16. WCRC Request

Buller District Council Information Request

Section A – General Information

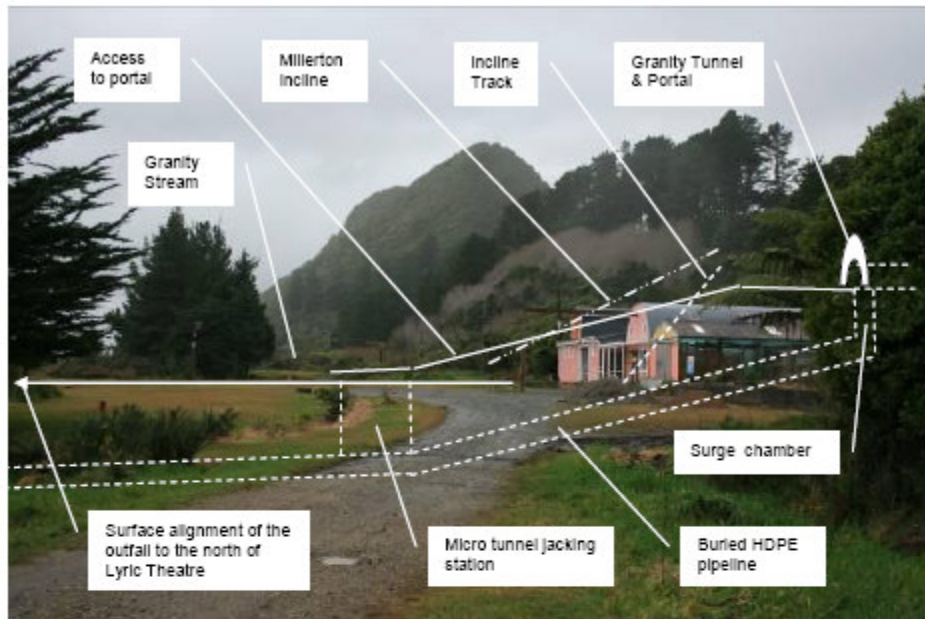
Provide a schematic diagram of the internal operating of the bulk head, machine hall for the proposed power stations

The power stations will be located in an underground chamber up to 150m from the tunnel portals. The exact location of the power houses will be determined by geotechnical investigations and conditions encountered during tunnel construction. Current estimations are that the first 50m of the tunnels will be through slope debris before granite basement is encountered, which would provide suitable foundation for the power houses.

The internal layout of the power stations have no bearing on the assessment of environmental

effects. Power station fitout will be a matter for final design and will be dictated by final decisions on installed capacity, among other things.
